**MOUNTAINSIDE WOODS – SUBDIVISION PUBLIC HEARING (CONTINUED)**  
**PUBLIC COMMENTS AND RESPONSES**  
**PART II**

On October 25, 2012, the Town of Lloyd Planning Board continued the public hearing on the subdivision for the Mountainside Woods project. The following is a list of the individuals who spoke at that public hearing.

**MOUNTAINSIDE WOODS  
VISTA DRIVE  
TOWN OF LLOYD  
ULSTER COUNTY, NEW YORK**

**Photo 1:**  
View of Inlet side of 3 – 24" Dia. Culverts beneath Mr. Indelicato's Driveway

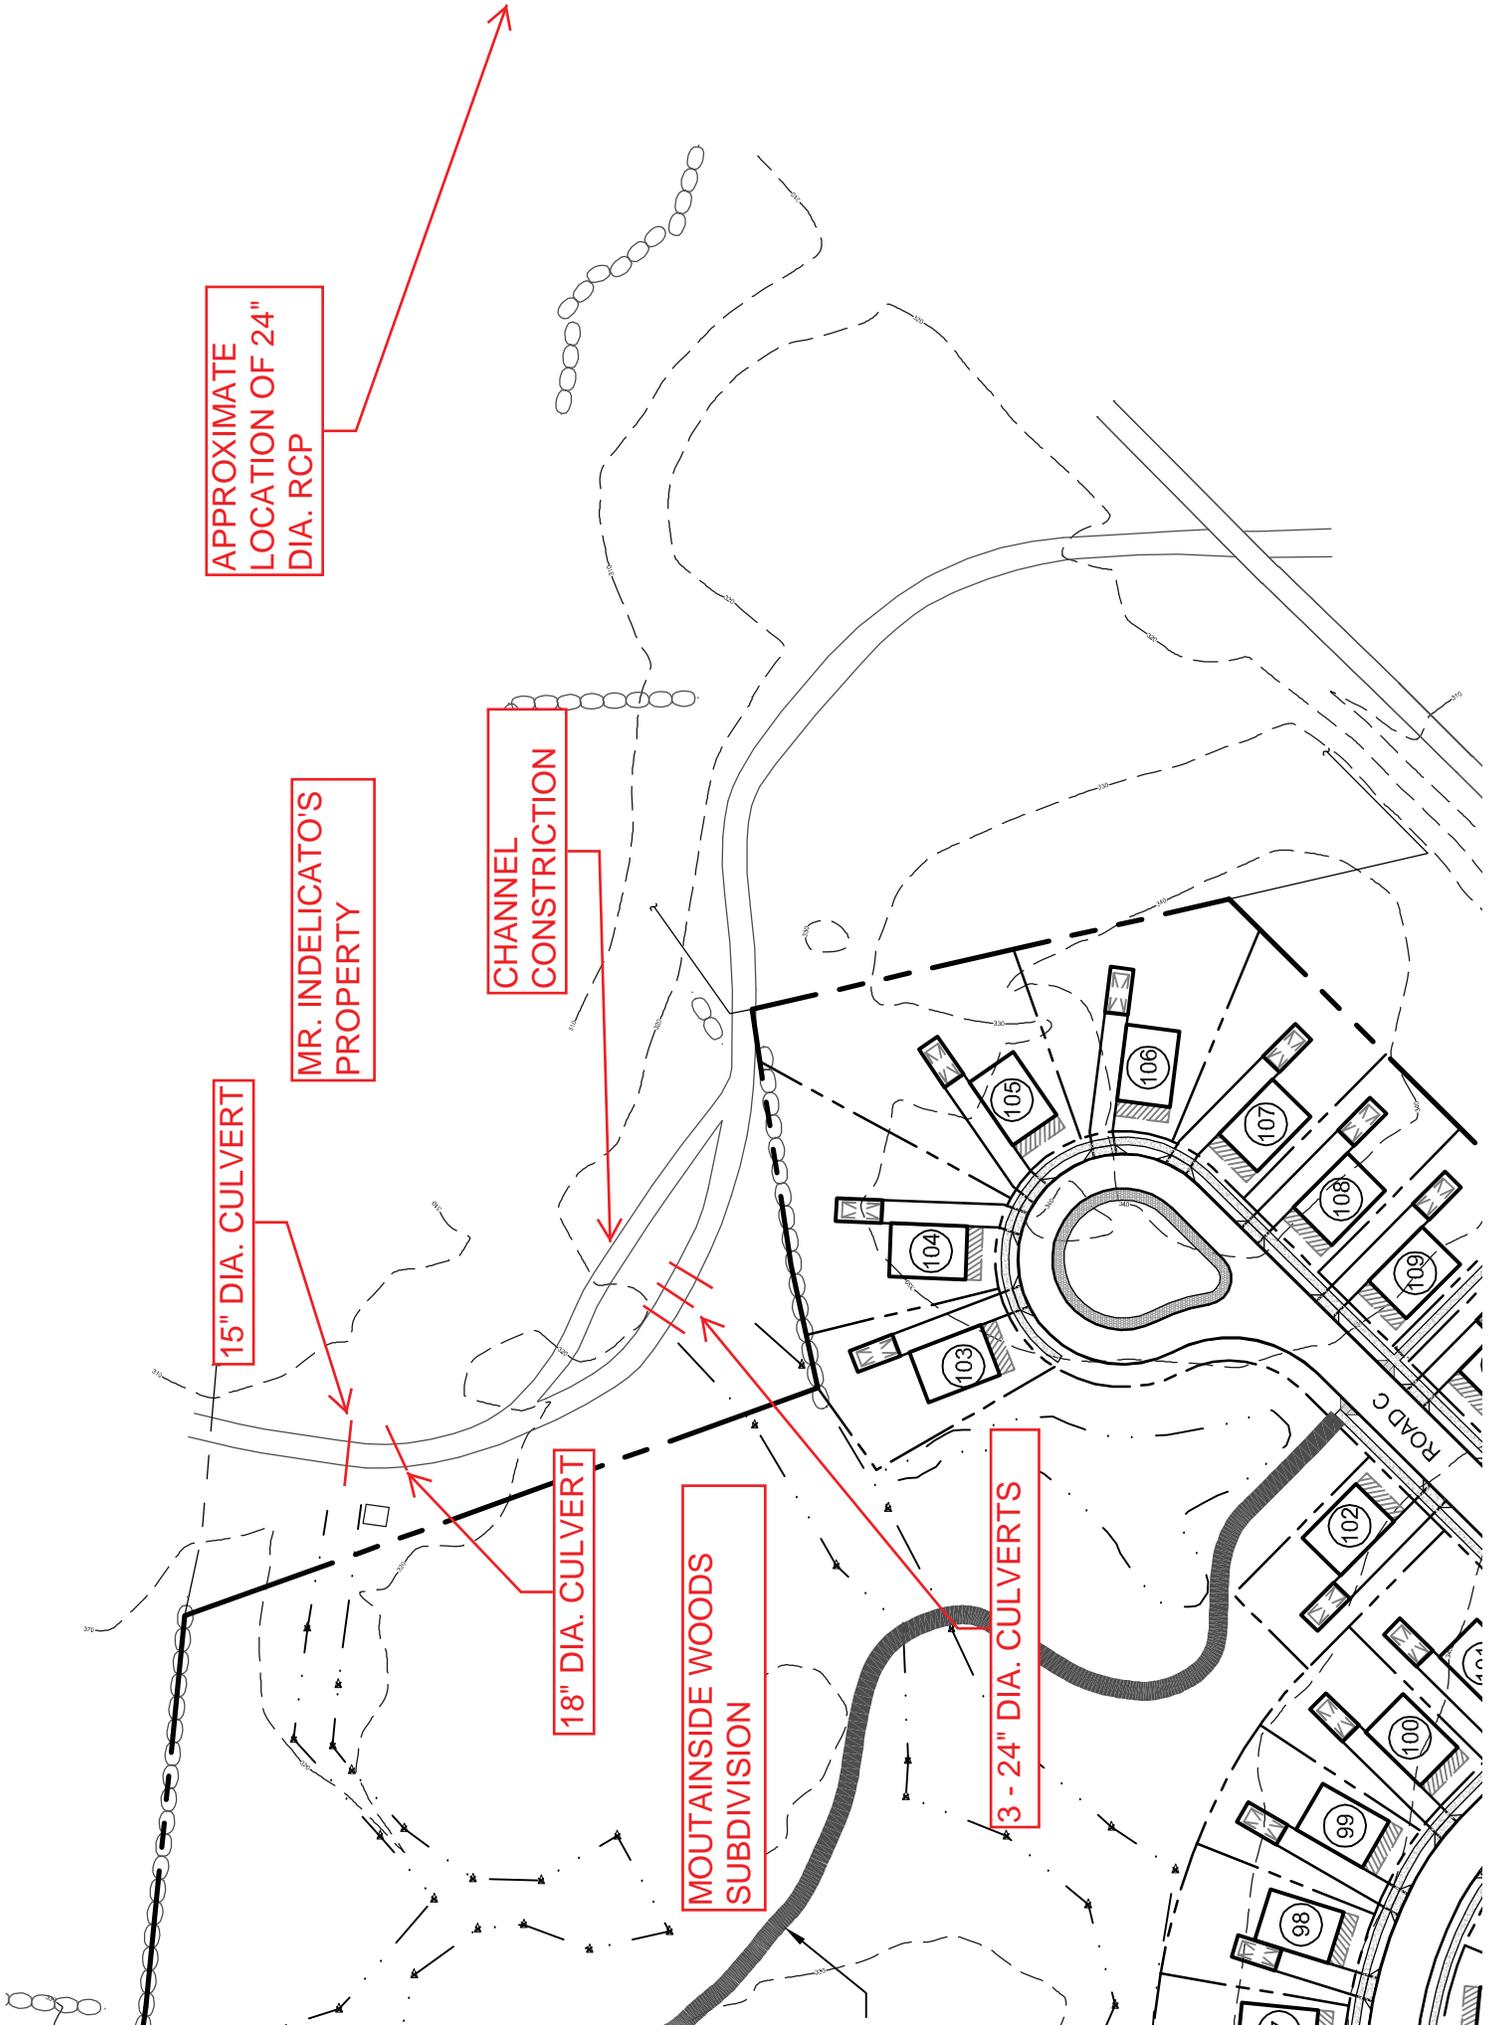
Mr. Indelicato's driveway, "the lane" as he refers to it, runs through the floodplain and crosses the stream. It was constructed with three 24 inch culverts which were installed beneath the driveway to accommodate the stream flow. These culverts have a combined capacity of approximately 125 cubic feet squared (cfs). In analyzing the 100 year storm event for this watershed, it is expected that over 500 cfs of runoff would be generated. Accordingly, the culverts installed by Mr. Indelicato on his property are one fourth the required size and it is understandable why his lane washes out, and property floods, even during much smaller rain events.

It is the opinion of the applicant's engineers that Mr. Indelicato's flooding problems are due to the fact that his driveway was constructed in a floodplain and that the culverts which were installed by Mr. Indelicato to accommodate the stream flow are severely undersized. For these reasons, regardless of whether the Mountainside Woods project is built, this flooding condition is likely to continue. Please refer to Morris Associates Memorandum and attachments dated November 15, 2012.
